PMRE-Iditarod Dog Sledding Historic District Workshop Summary and Implementation Plan

***Port MacKenzie Rail Extension Project
Iditarod Dog Sledding Historic District Workshop Summary
and Implementation Plan***

Exhibit 1: Iditarod NHT crossing design before and after the IDSHD Workshops

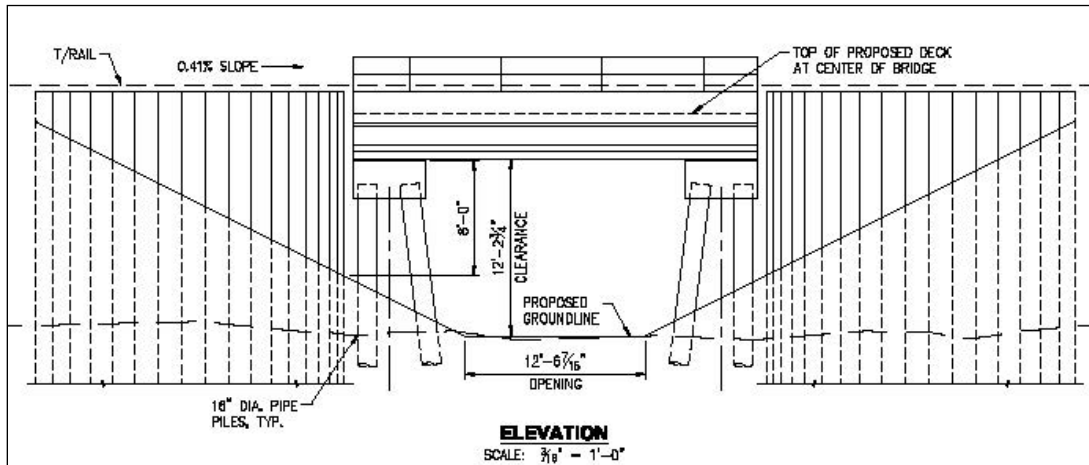
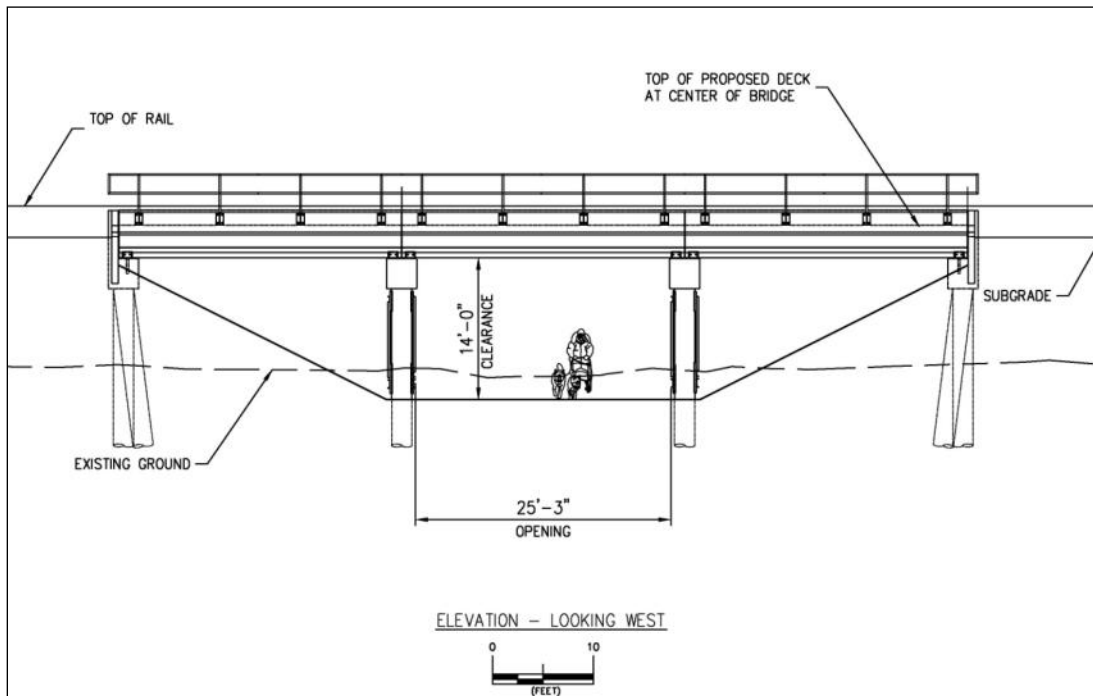
Redesign bridges/crossings with the vertical clearance increased to a minimum of 14' whenever possible (Issue 1)

Workshop participants stated that the height (vertical clearance) of crossings needs to be increased to more than 12' to account for snow depth, accommodate equipment for grooming of trails, and enhance safety. The initial clearance presented at Workshop 1 was as low as 10' for some crossings. The Project Team committed to redesigning bridges/crossings with the vertical clearance increased to a minimum of 14', whenever possible. Vertical clearances will range from 12' to over 18' (see Table 4). Only two crossing structures, located south of the Agricultural District, will have a vertical clearance less than 14'. Baker Farm Bridge (Crossing 16) will be a three-span bridge providing between approximately 12' vertical and 25' horizontal clearance. This crossing is adjacent to the Baker Farm Road at-grade crossing (Crossing 17), which provides an alternative crossing option in the vicinity. The Figure 8 Lake Loop trailhead crossing (Crossing 18) will be accommodated by a 19' diameter plate pipe, providing between approximately 9' and 14' vertical by 16' horizontal clearance. A bridge crossing in this location is not practicable due to the poor soil conditions and high-railroad embankment through the area. Alternative access for over-height vehicles is provided by the access road from Lu Young Lane, south of the Bulk Material Bi-modal Facility (BMBF).

Exhibit 1 shows a comparison of the Iditarod NHT crossing (Crossing 10) proposed at Workshop 1 and the currently proposed crossing that has been refined based on comments from trail users. The vertical clearance was increased from approximately 12' to 14'.

Exhibit 2: Approach example

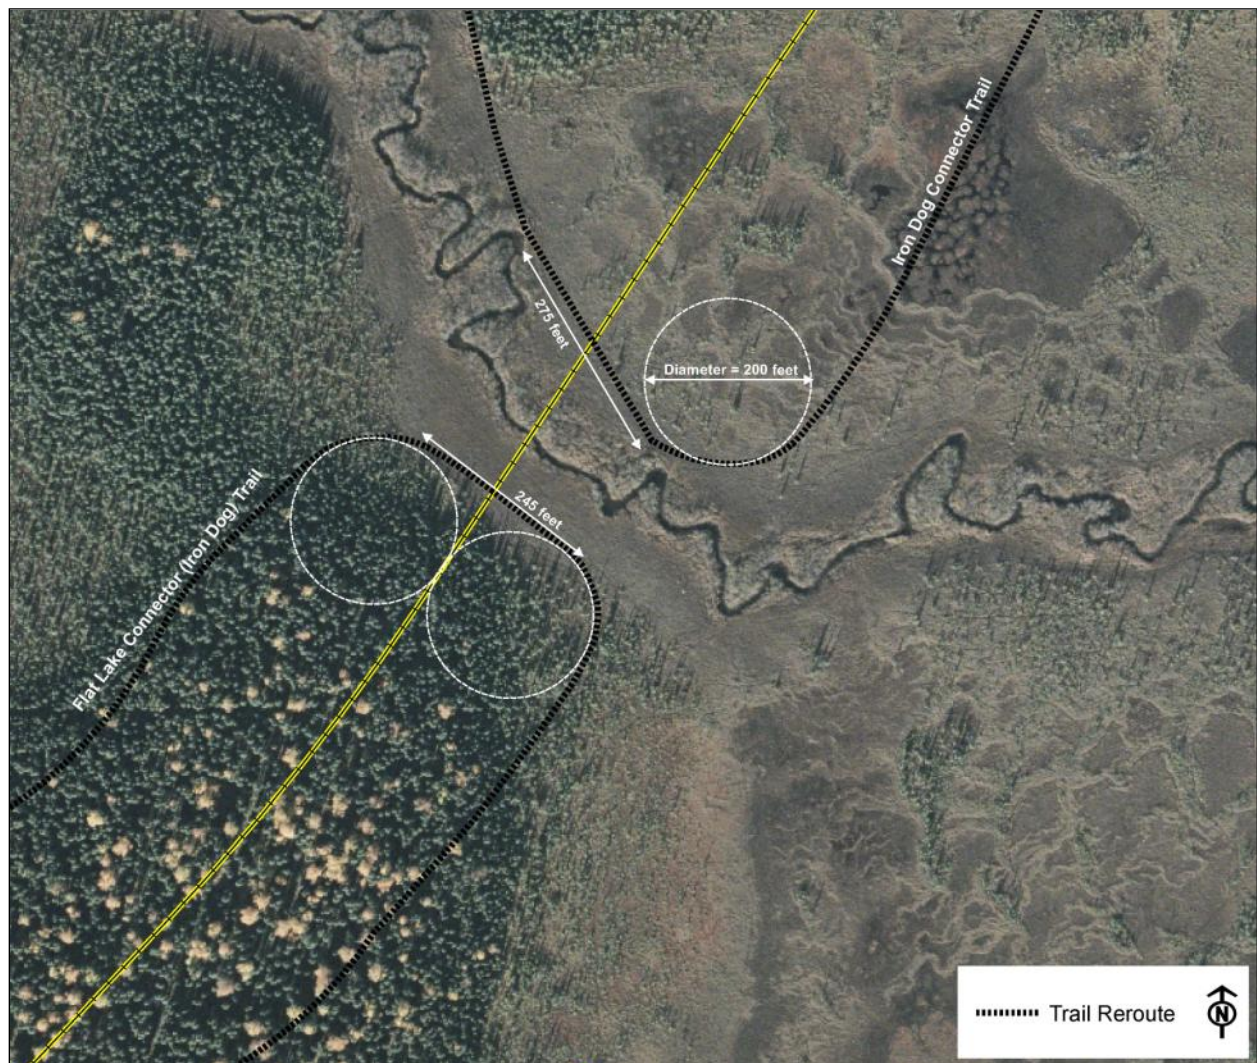
Develop standards for sight distance needs and crossing approaches to accommodate a 100'-long vehicle/dog team (minimum 60' turn radius; Issue 2)

As stated by workshop participants, in reference to the rerouted trails (specifically the separated-grade crossing at Milepost (MP) K22.8 Tributary of the Little Susitna River [Crossing 5]), the length of a sled dog team with 16 to 20 dogs (approximately 85') needs to be considered during design of trail approaches to crossings to ensure curves are not too tight. Exhibit 2 illustrates typical design changes to approaches to address line of sight issues for trail reroutes. The Project Team worked with Sustainable Design Group to develop standards for sight distance needs and crossing approaches. A 100' long vehicle/dog team requires a minimum 60' turn radius. The design standards for trail approaches to crossings include gentle curves with turn radii between 75' and 90', which will allow for a 100' long dog team to turn and safely pass through the structure while allowing adequate line of sight for trail users prior to passage.

Exhibit 3: Crossing 5 profile view

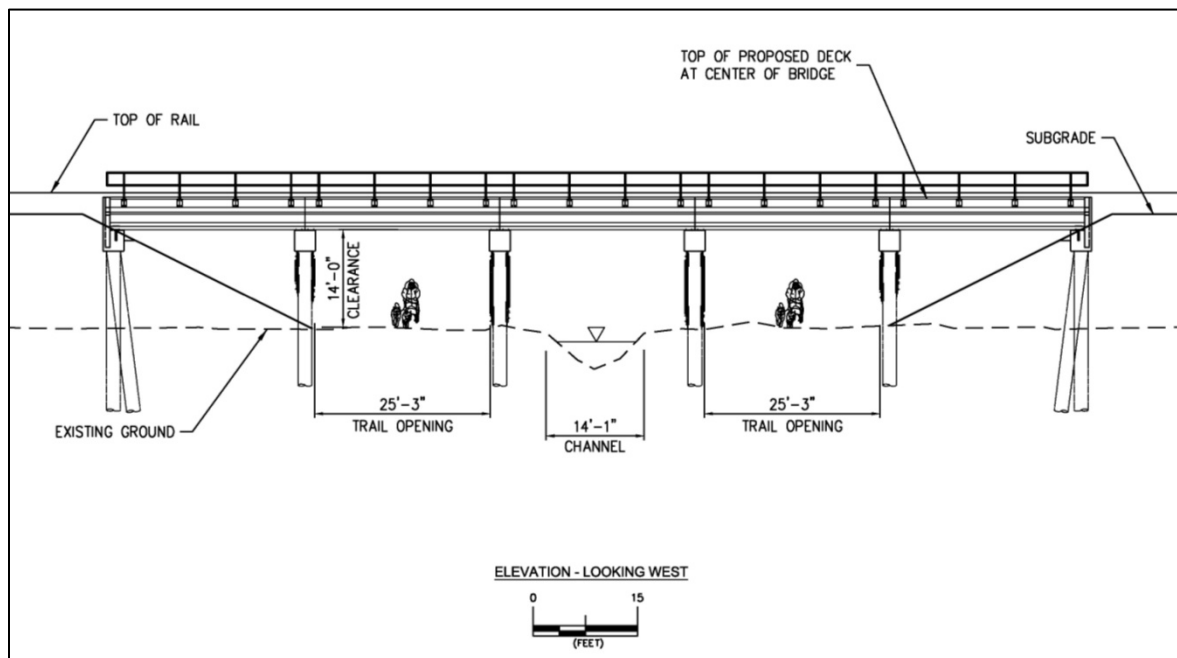
Provide a crossing for the Iron Dog Connector Trail and the Flat Lake Connector Trail (Issues 8 and 9)

Participants requested that the Project include crossings for the Iron Dog Connector and Flat Lake Connector trails. The Iron Dog Connector Trail (Big Lake Trail #5) is identified in MSB trail plans as a winter use only trail that traverses wetlands and lakes. Due to safety concerns, wetland and regulatory concerns, tree cover, and topography, a crossing is not a good option at its current location (see Section 4.2).

To meet trail user crossing needs and allow for a safe crossing, the Project Team proposes to reroute the Iron Dog Connector and Flat Lake Connector trails to a multi-use crossing structure at MP K 22.8 over an unnamed tributary to the Susitna River (Crossing 5; Figure 1). This five-span bridge will have approximately 25' of horizontal clearance for three spans and a minimum of 14' of vertical clearance (Exhibit 3).

The Project Team has developed design standards for Crossing 5 and these reroutes to provide safe crossings (e.g., increased horizontal and vertical clearance for better line of sight). Crossing 5 has been modified since Workshop 1 based on input from participants. The original design for Crossing 5 was a three-span bridge with 12'-7.5" of vertical clearance, two spans with 14' horizontal clearance, and a center span with over 25' of horizontal clearance. The design presented in the draft *Implementation Plan* for Crossing 5 included vertical clearances of more than 17' and horizontal clearances of more than 25'. However, the current vertical clearance will be a minimum of 14' to reduce wetland impacts. The structure will accommodate a trail on both the north and south side of the creek, each with a horizontal clearance of more than 25'. Exhibit 3 shows the most recent proposed design for Crossing 5.

Exhibit 5: Possible Iditarod Race Trail Reroute and Crossings

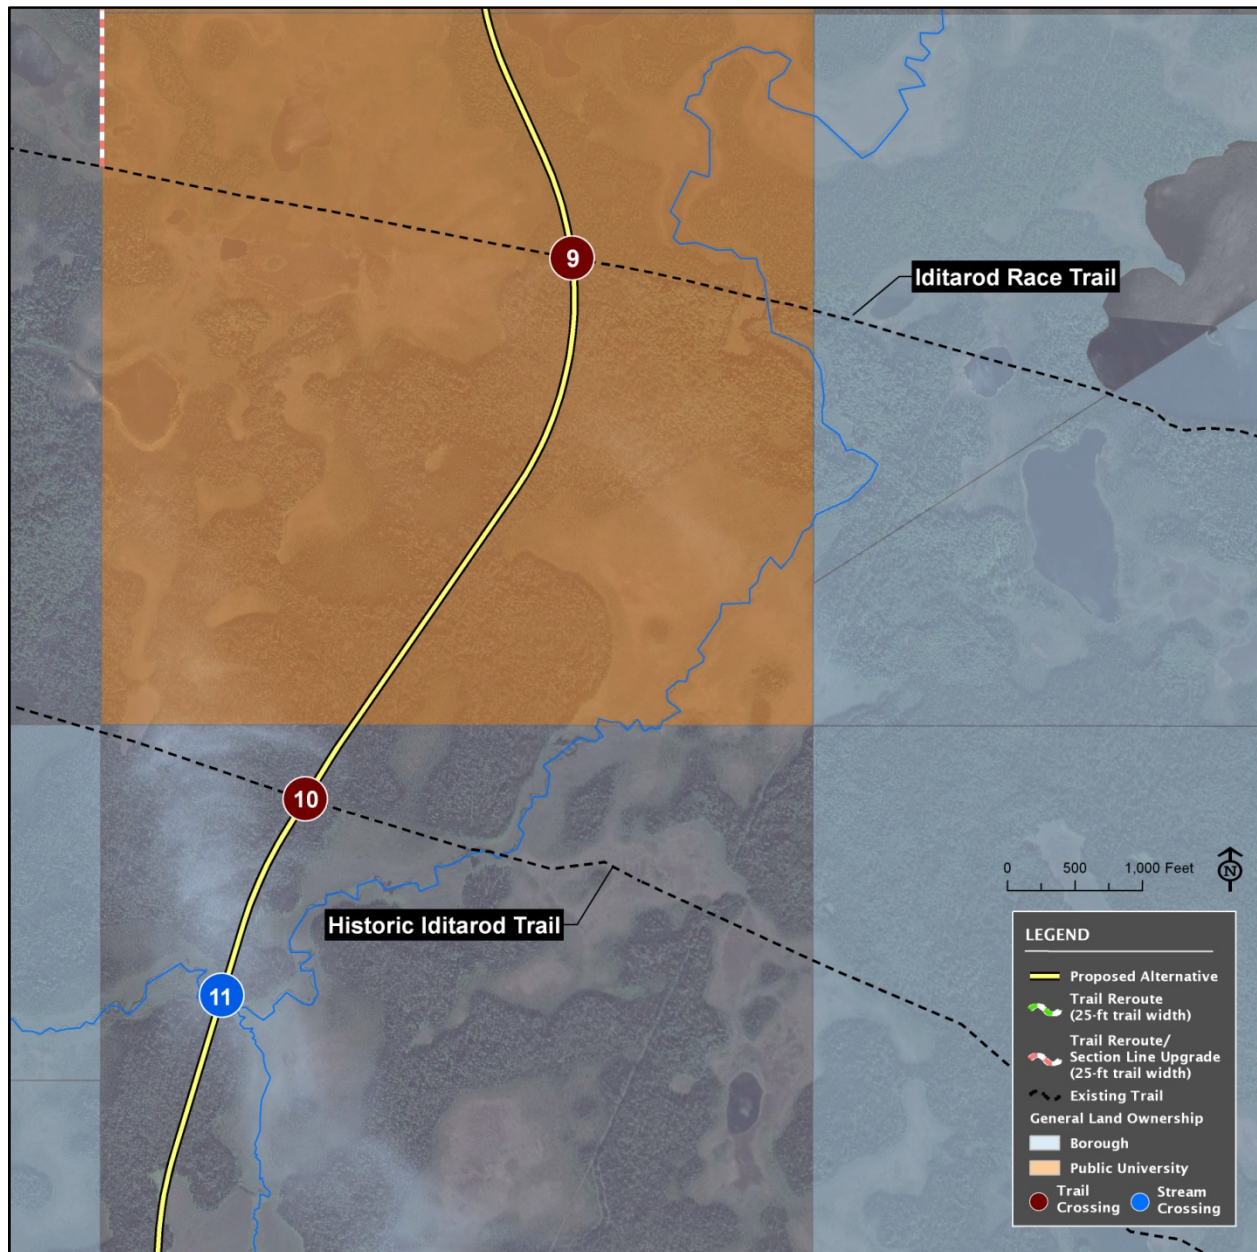
Provide crossing for the Iditarod Race Trail; obtain an easement from the University of Alaska (Issue 11)

Workshop participants stated that the Project needs to provide a crossing for the Iditarod Race Trail (Crossing 9) and obtain an easement from the University of Alaska for this trail should one not currently exist. It was learned during the course of the workshops/meeting that an easement does not currently exist for the Iditarod Race Trail. This trail has reportedly hosted 20 Iditarod races and is used more frequently/regularly than the Iditarod NHT. Participants indicated that a separated grade crossing (bridge) is preferred, but if a bridge is not possible, an at-grade crossing would be better than no crossing at all.

Approaches to a crossing for the Iditarod Race Trail would be on UA land. Since no easement currently exists at this location, the MSB continues to work with UA to secure an easement. This issue is anticipated to be resolved by the end of 2012. The proposed Iditarod Race Trail crossing (Crossing 9) would be a typical three-span bridge with a minimum 14' vertical clearance, and approximately 25' of horizontal clearance in the center span (see Exhibit 1 as an example of a typical three-span bridge). This crossing will involve excavation and grading of the trail to obtain 14-feet of vertical clearance and 20' of horizontal clearance at the current crossing location. Approach improvements would include widening the trail in the vicinity of the crossing.

The Project Team is committed to continuing access and connectivity in association with the Iditarod Race Trail, a trail that IDSHD workshop/open house participants indicated was important to the IDSHD. If negotiations with UA to secure an easement are unsuccessful, a crossing cannot be provided for the Iditarod Race Trail at its current location as it would encourage trespassing on UA property. The Iditarod Race Trail would instead be rerouted to the Iditarod NHT, which would be upgraded/improved to accommodate the potential increase in users (Exhibit 5).

The Project Team will provide a separated grade crossing for the Iditarod NHT (Table 4 and Attachment A, Figure 1). Although the original crossing designs for this trail included a single span crossing with 12' of vertical and 14' of horizontal clearance, the crossing structure was redesigned to include a three-span bridge with 14' of vertical clearance and over 25' of horizontal clearance (see Exhibit 1 for a comparison of early and current crossing design). Although only the central span of the bridge will be passable for trail users, the north and south spans increase visibility for potential oncoming traffic. The Iditarod NHT will be improved where it passes beneath the rail embankment using standards for sight distance needs and crossing approaches to accommodate a 100' long vehicle/dog team (i.e., turn radii between 75' and 90'; see Exhibit 5).

Exhibit 6: Connectivity between Crossings 7 and 10

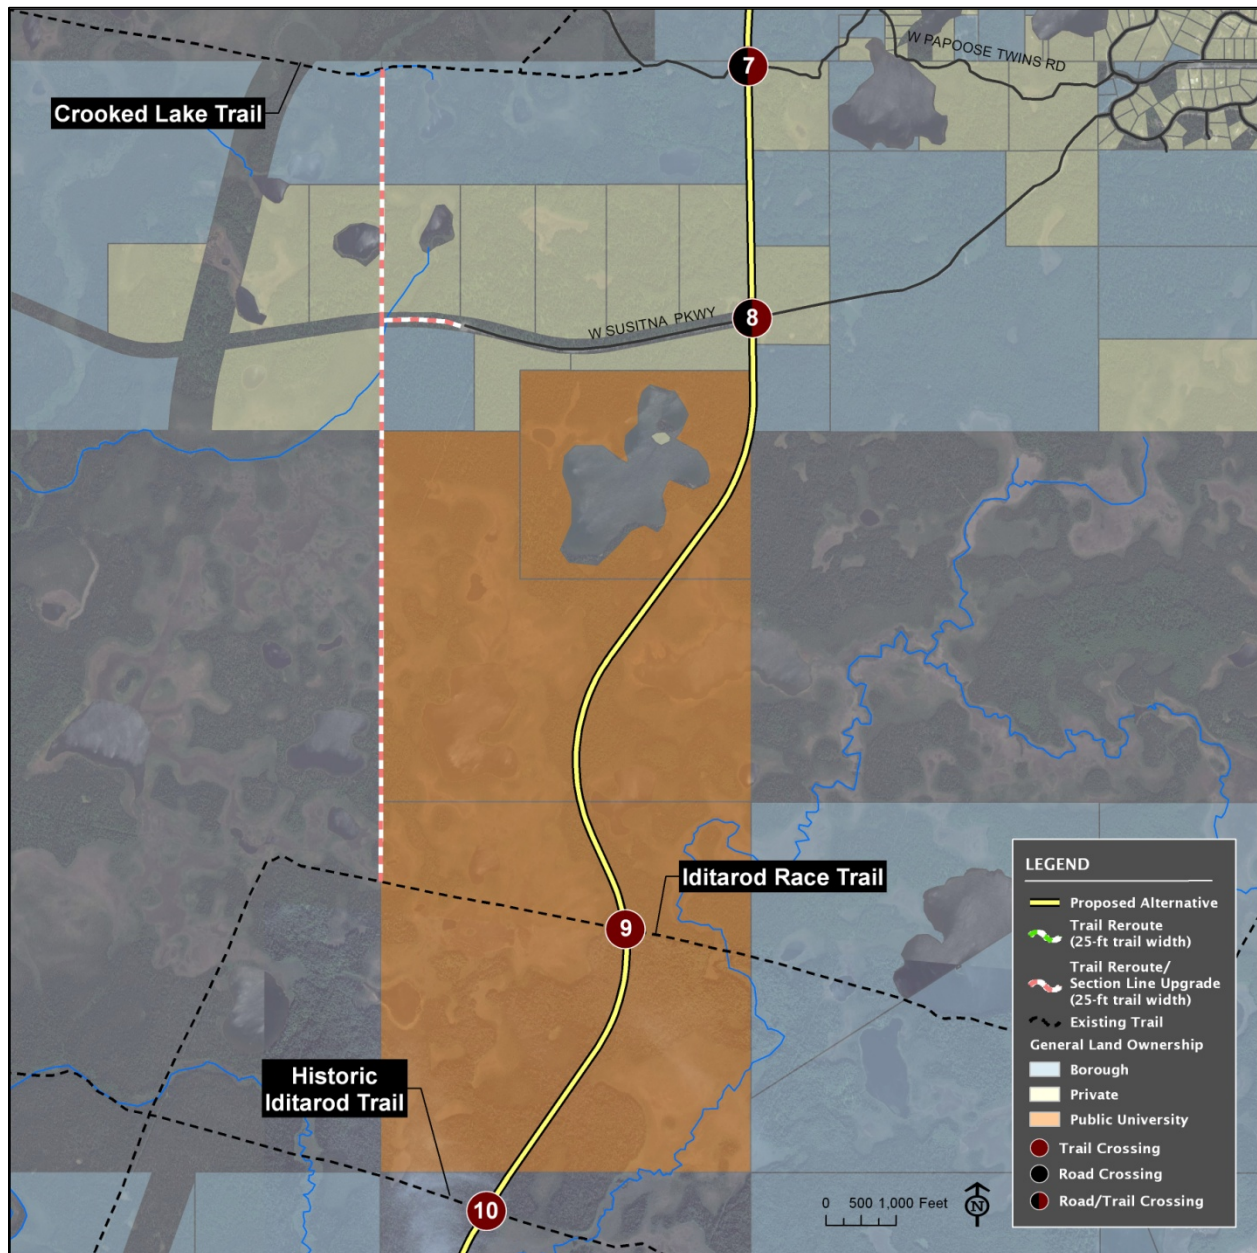
Provide a trail(s) along one or both sides of the proposed ROW to maintain connectivity (Issue 14)

The Project Team evaluated participants' recommendation for a north-south trail along one or both sides of the proposed ROW to help maintain connectivity. Trail reroutes, enhanced crossing structures and strategies to maintain connectivity in a safe manner are all measures the Project Team has and continues to work toward as this project moves forward. The proposed railroad alignment is orientated predominately north-south, and most of the trails identified both in the Final EIS and IDSHD workshops that provide north-south movement will remain intact. Providing additional north-south corridors along one or both sides of the rail line has many challenges such as FAA VORTAC issues, safety concerns, wetland and regulatory concerns, land ownership, tree cover, topography and cost of constructing additional bridge structures (see Section 4.2). Based upon current north-south connectivity (Attachment A, Figure 4) and the issues identified above, a new trail(s) paralleling the proposed ROW for the project is not planned.

The existing trail system west of the proposed rail corridor provides a north-south corridor (Attachment A, Figure 4). However, one area of concern for north-south connectivity has been identified between Crossings 7 and 10 (Exhibit 6). This area demonstrates the biggest gap in connectivity and is owned primarily by UA. The Project Team has developed an alternative corridor for north-south travel in this area that may offer a solution for trail users and property owners (see Exhibit 6 and Attachment A, Figure 4). We will continue to work with local trails groups/users, regulatory agencies, land owners and other interested parties to maintain connectivity in the IDSHD.
